Register Reference : 91A/0619

Development : Extension to warehouse, together with associated site
development works

LOCATION : Ballymount Road, Dublin 22.

Applicant : Commercial Refrigeration Ltd

Job No. 857
Title
Date Oct 1991
Sheet No. 1
Drawn By FJF

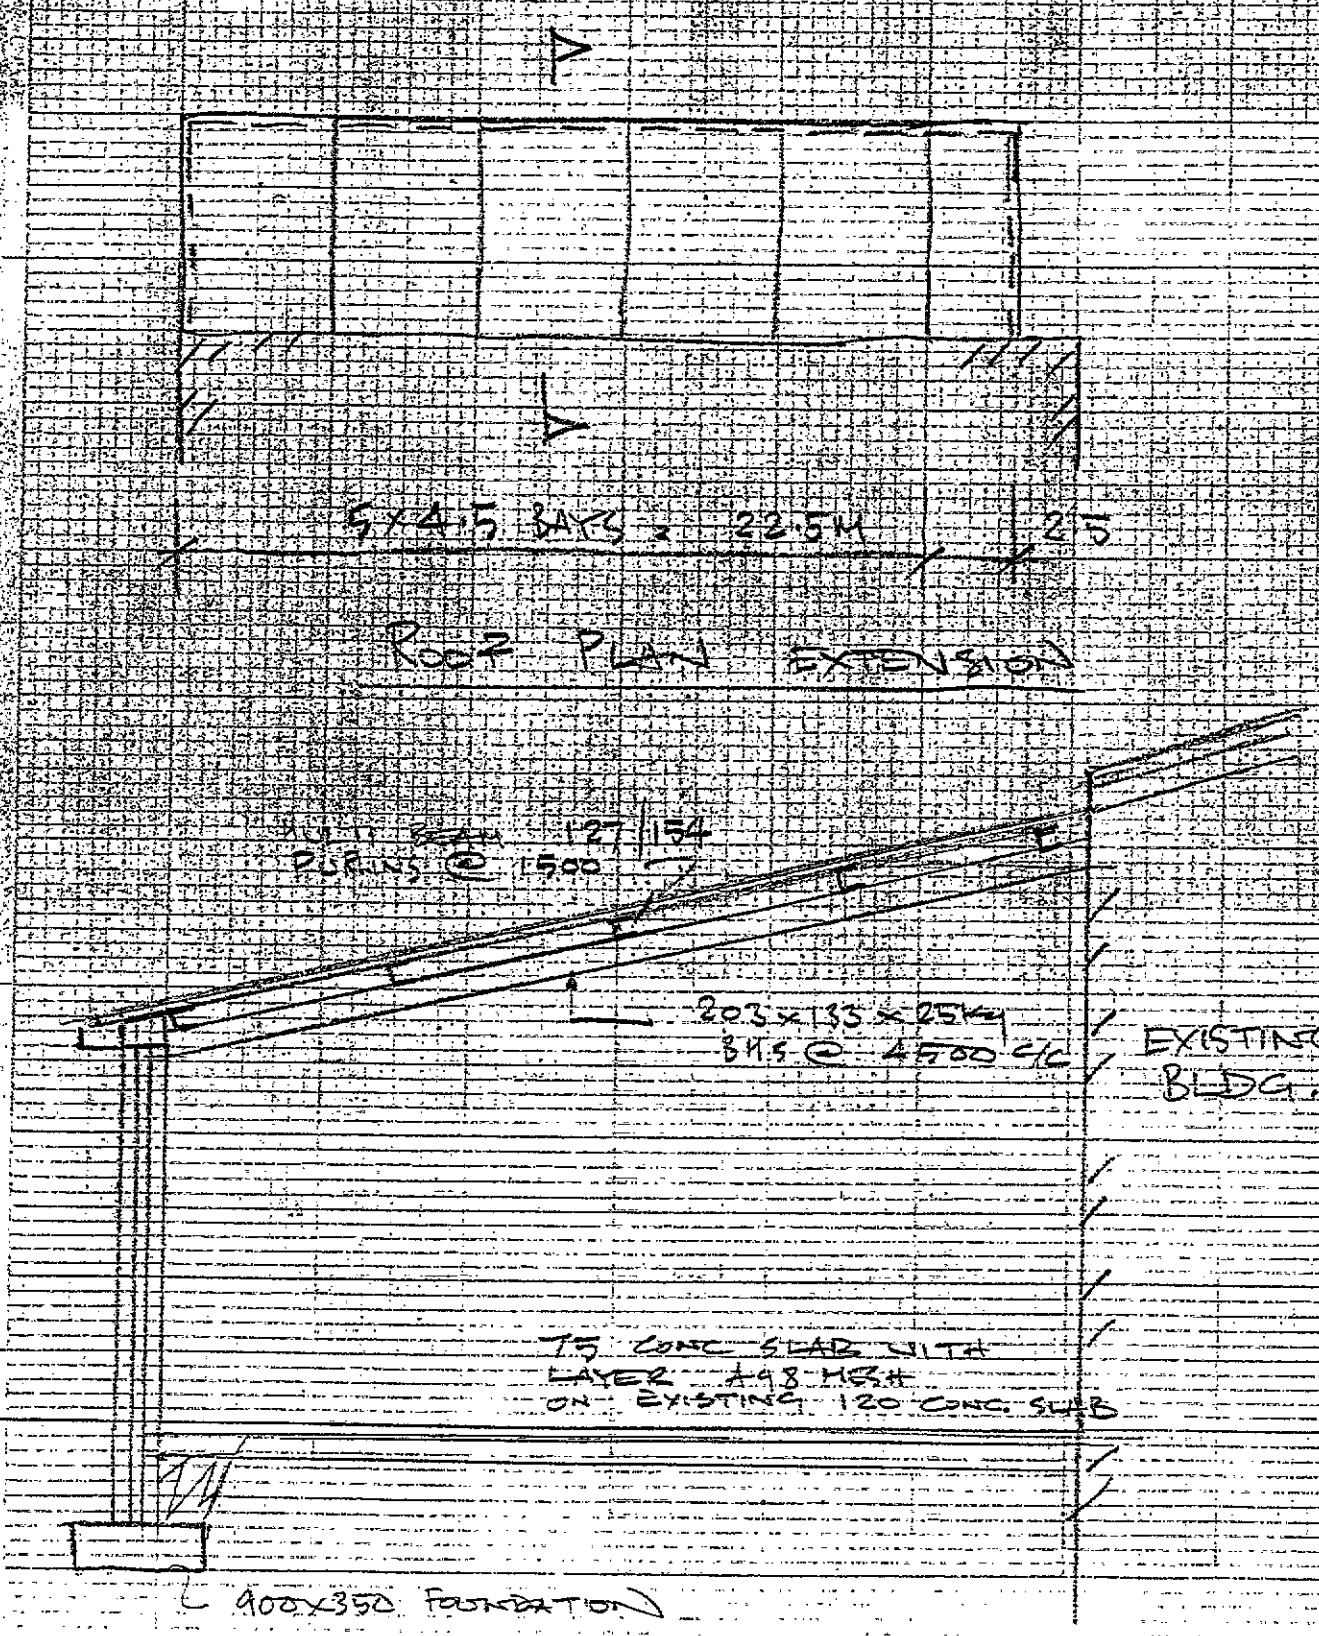
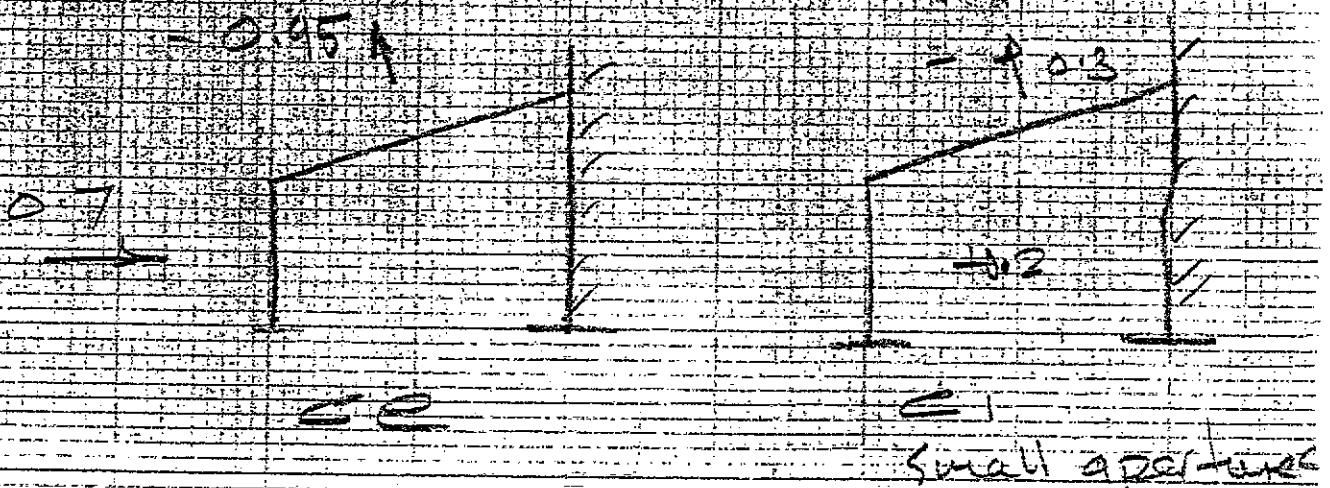
With reference to your letter of July 23rd and discussions between your Mr. John Kearney and the builder - Maurice Keller - Accordingly the following points are now covered -

- 1) Location of Block Plan forwarded through our submission of September 12th.
- 2) Specification forwarded through our submission of September 12th.
- 3) Confirmed through our submission of September 12th.
- 4) Structural details are now enclosed - (By Frank Fox & Associates).
- 5) Details confirmed through our submission of September 12th.
- 6) Sub-structure details are enclosed - (by Frank Fox & Associates). The existing slab is being retained and finished with a meshed screed of a minimum 3".

P.S/ Enclosed are further details engrossed on Engineers Drg 857/1A.
(Notes added.)

Title: BLOCK PLAN.

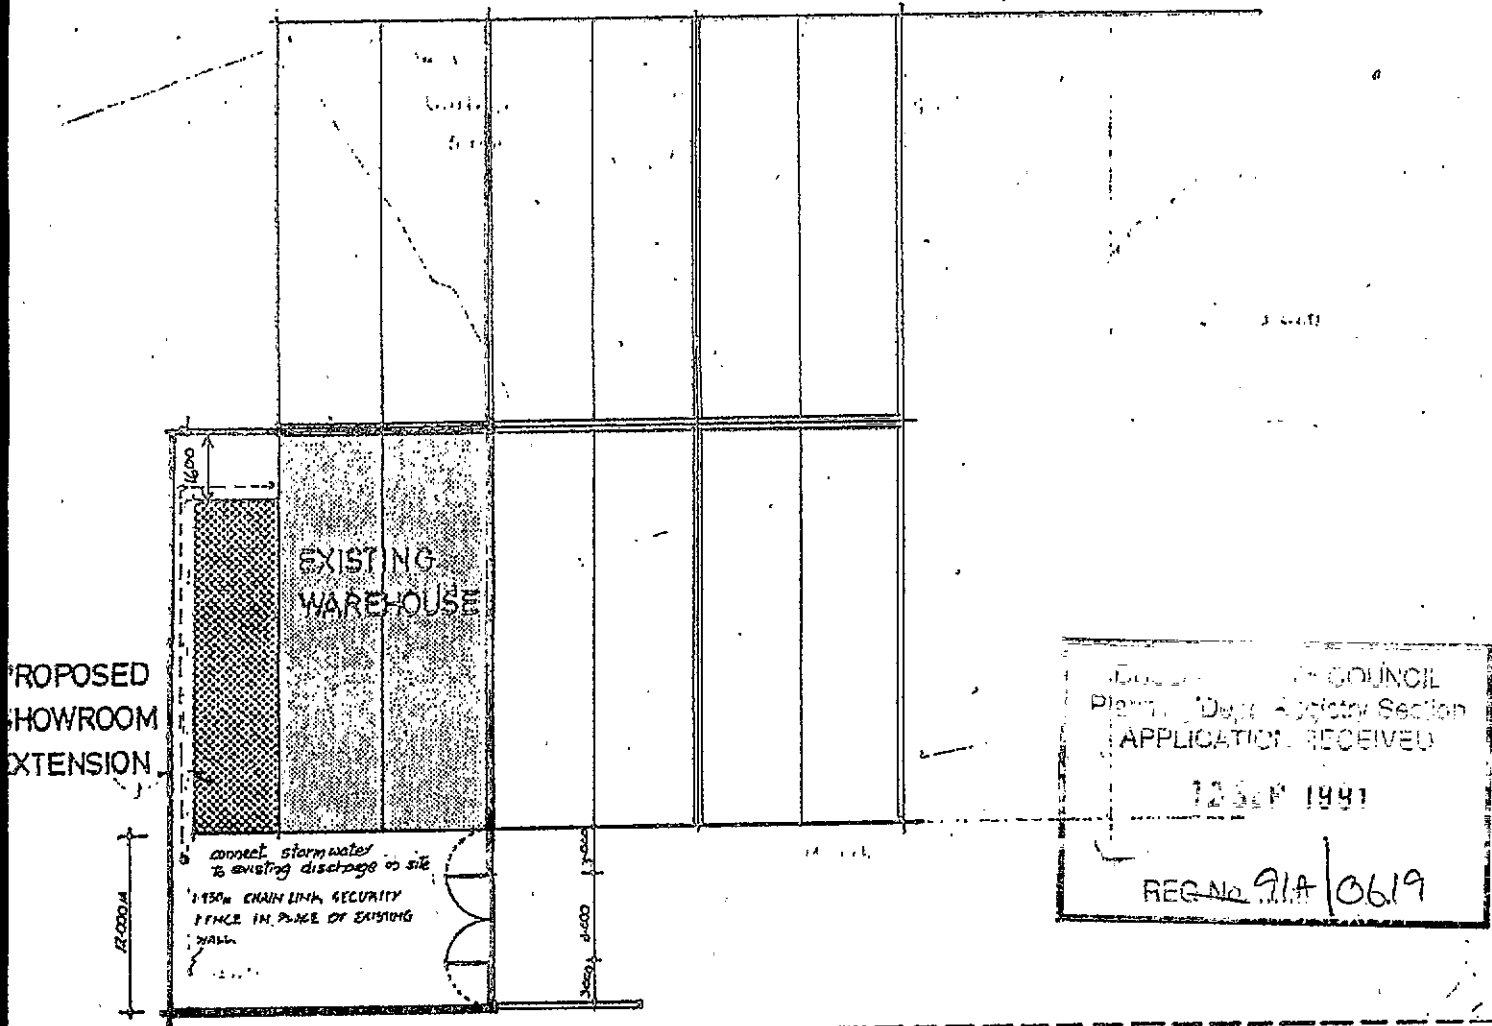
Vision at the existing access is obscured by hedges to the north.

- 1) Applicant to state if he can relocated the access to the southern end of site frontage to improve vision.
- 2) 5 extra car parking spaces to be shown on site plans.

The proposal appears to give a site coverage of 93.58% on this site. There is no indication on the layout of any car parking proposals.

- (1) Copy of location plan and block plan are included herewith.
- (2) Copies of the specification are included herewith.
- (3) Detail of the stormwater drain are included on the
block plan. These are shown as altered and discharging
through to the existing stormwater disposal system from
the site.
